# *Nomad*

## SERVICE BULLETIN

### CREW SEATS – RELOCATION TO AVOID PROPELLER PLANE

**Figure 1 Forward Collar**

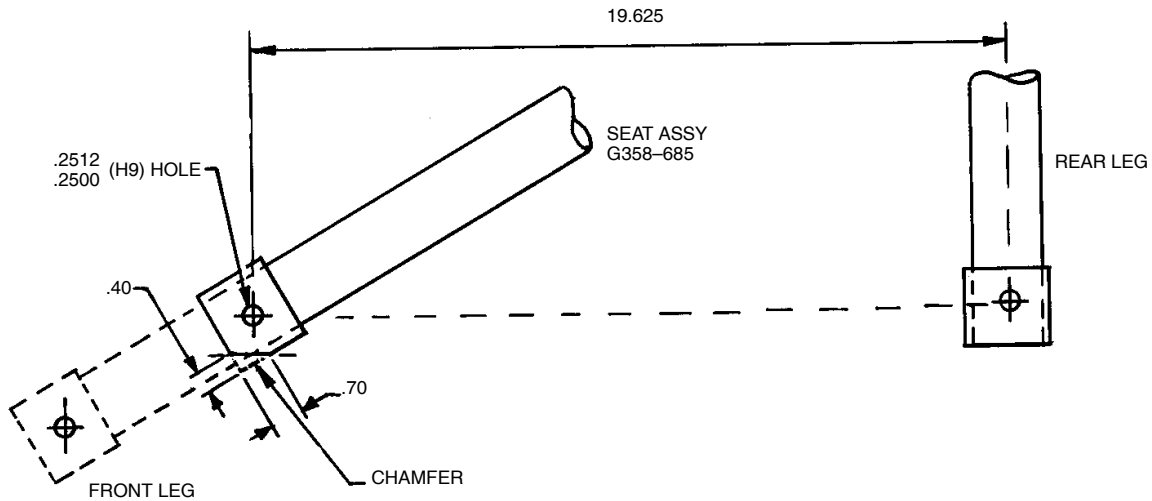
- (2) Drill new attachment holes .2512/.2500 dia. H9 in each front leg 19.625 inches forward of the rear attach hole as shown in Fig 1. Refit the collars in the new position and cut off the leg flush with the lower end of the collar. In order to clear the aircraft floor when the seats are refitted it will be necessary to file a chamfer on the lower side of each forward collar as shown in Fig 1.

**Figure 2 Rear Seat Attachment**

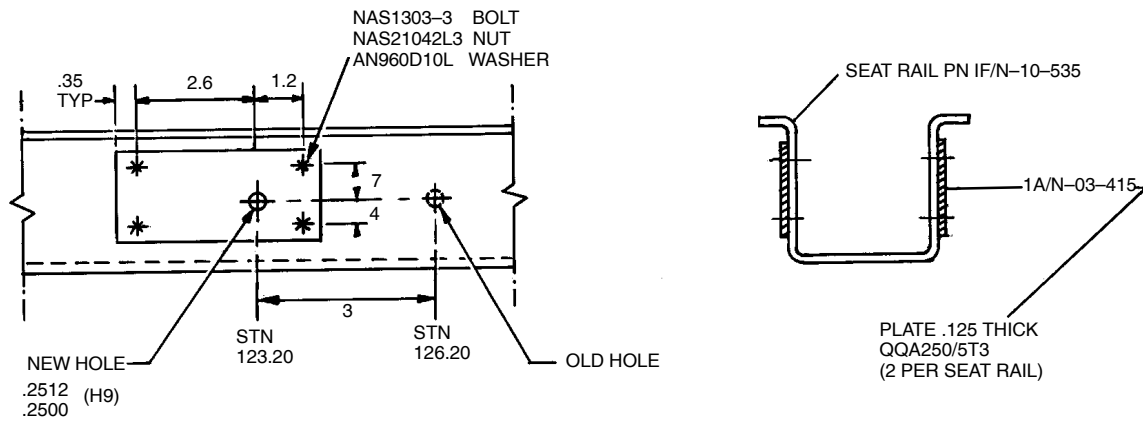
- B. Rework seat rails PN 1F/N-10-535 (4 each) as detailed below and as shown in Fig 2 and 3.
- (1) Make and fit reinforcing plates (PN 1A/N-03-415) to the outer faces of each seat rail per Fig 2. Drill new rear seat attach holes in each seat rail at Stn 123-20 i.e. 3 inches forward of existing rear hole.

**Figure 3 Front Seat Attachment**

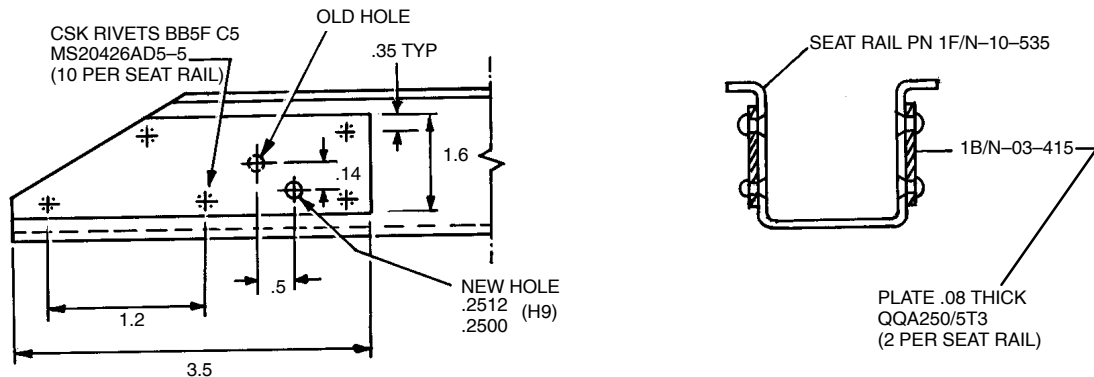
- (2) Make and fit reinforcing plates (PN 1B/N-03-415) to the outer surface of each seat rail per Fig 3 at the forward seat leg position.
  - (3) Before drilling the new hole (.2512/.2500 dia H9) as shown in Fig 3 place the seat in position, temporarily fit the bolts in the rear legs and check the position of the hole in the front leg, which should be 0.14 inch below horizontal datum. Drill .2512/.2500 inch dia H9 hole.

**Figure 4 Column Tube**

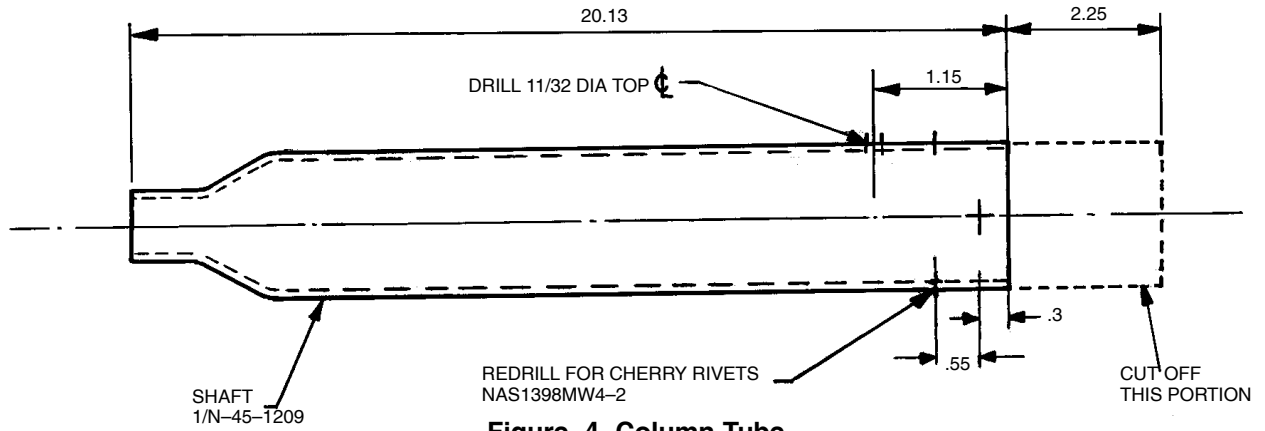
- (2) Remove the hand wheels from both column tubes PN 1/N-45-1209. Reduce tube length to 20.13 inches. Refer Fig 4. Drill new hole 11/32 dia through the top centre line of the tube for the gust lock and refit handwheel.

**Figure 5 LH GUARD ASSY**

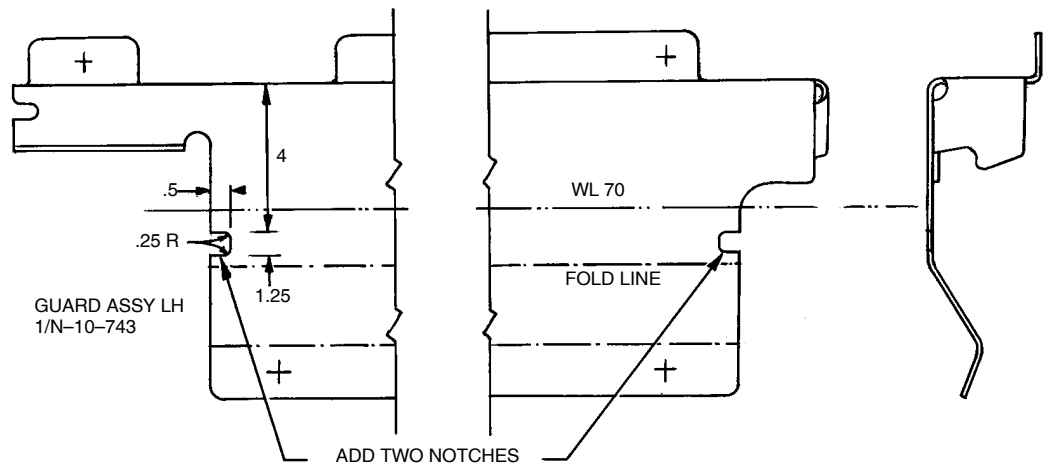
- D. Remove floor panels PN 1/N-10-737 from both sides and take the following action:
- (1) Cut notches as shown in Fig 5 and 6 to left and right hand guards PN 1/N-10-743 and 1/N-10-744. These are required to ensure clearance for nuts on the brake linkage system.
  - (2) To allow for the shortening of the rudder control rods in Para F. it will be necessary to increase the length of slots in the brush sealed slots by filing upper and lower rudder pedal guards PN 1/N-10-745, -746, -749, -750, -751, -752, -757 and -758 at the forward end as shown in Fig 7,

**Figure 8 Rudder Pedal Rubbing Strip**

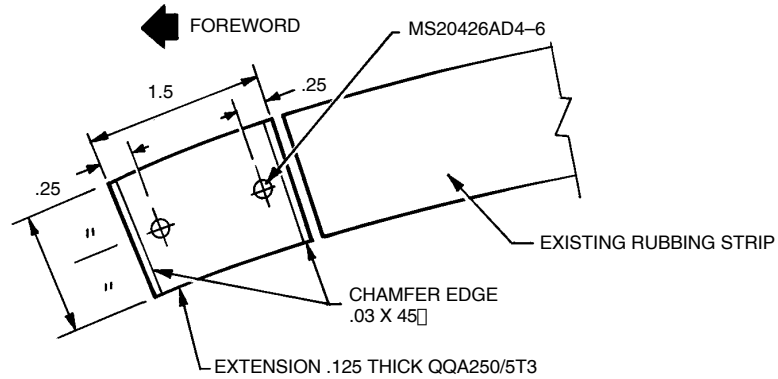
On left and right hand nosewheel well walls add extension to rudder pedal rubbing strips as shown in Fig 8.

**Figure 9 LH & RH AUX INSTRUMENT PANELS**

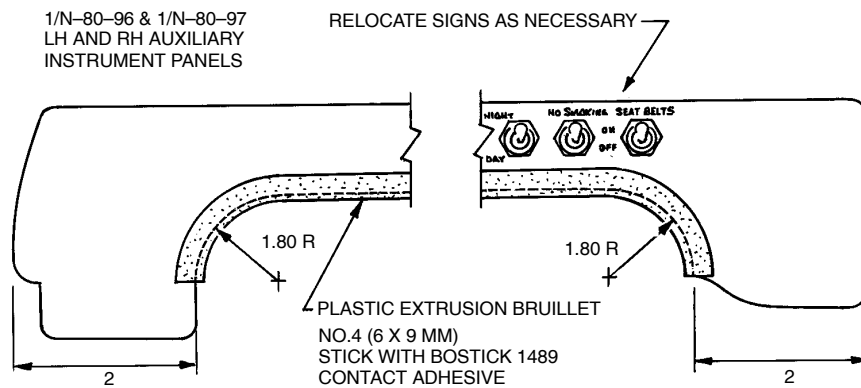
- E. Remove the lower right and left hand auxiliary instrument panels and rework as shown in Fig 9 to give additional leg clearance. Relocation of equipment fitted to these panels are covered on Service Bulletins N22-35-1 and N22-24-1. Refit panels after rework.
- F. On the pilots side remove the rudder control rods PN 1/N-45-1148 as per MM. Chap 27-20-00 and rework by shortening the rods as shown in Fig 10. Refit the two control rods.

**Figure 11 GUST LOCK**

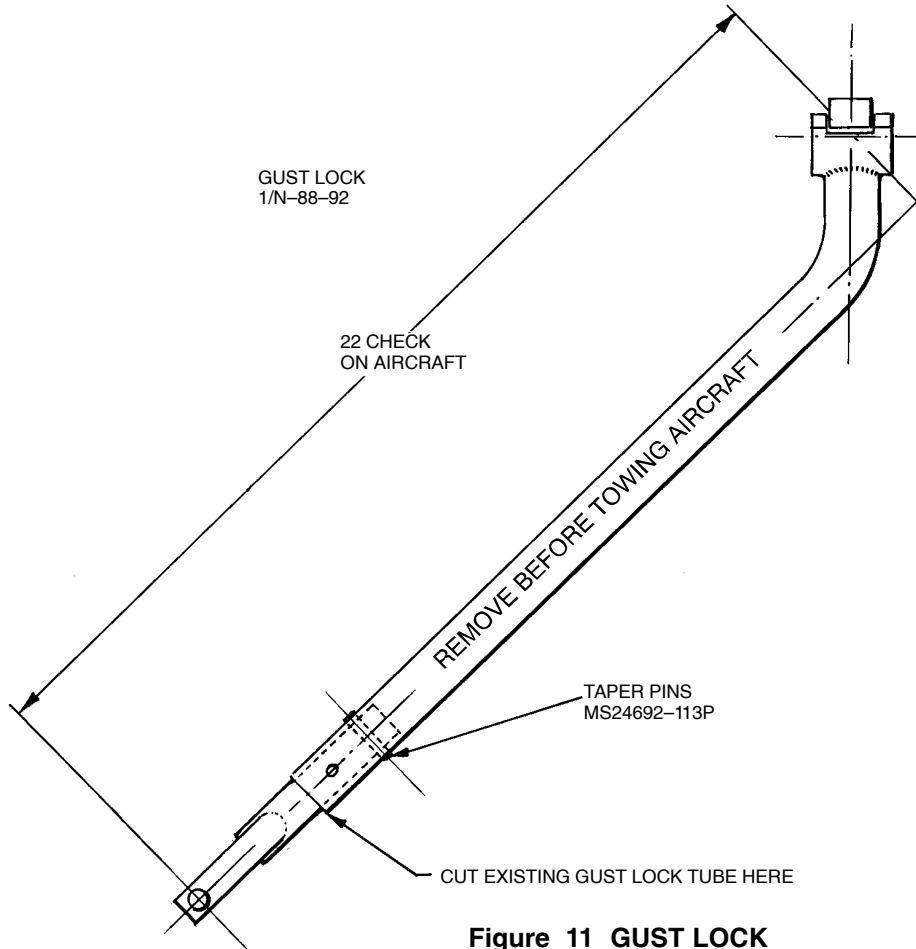
Repeat on the co pilots side.
- G. Rework the Gust Lock PN 1/N-88-92 by fitting modified gust lock base PN 1/N-88-172 per Fig 11. Do not finally drill and pin the cut off top portion of existing lock until the gust lock has been located on the aircraft. When a satisfactory fit is obtained drill and fit taper pins.
- H. Modify the gust lock stowage under the right hand pilots seat as shown in Fig 12.

**Figure 12 Gust Lock Stowage**

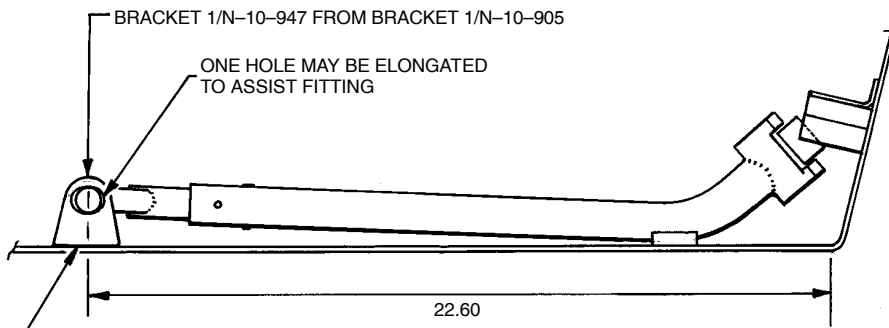
REPOSITION THIS BRACKET TO NEW DIMENSION AND ATTACH WITH POP RIVETS AGS2050/424BS  
(EXISTING HOLES MAY BE LEFT REDUNDANT)
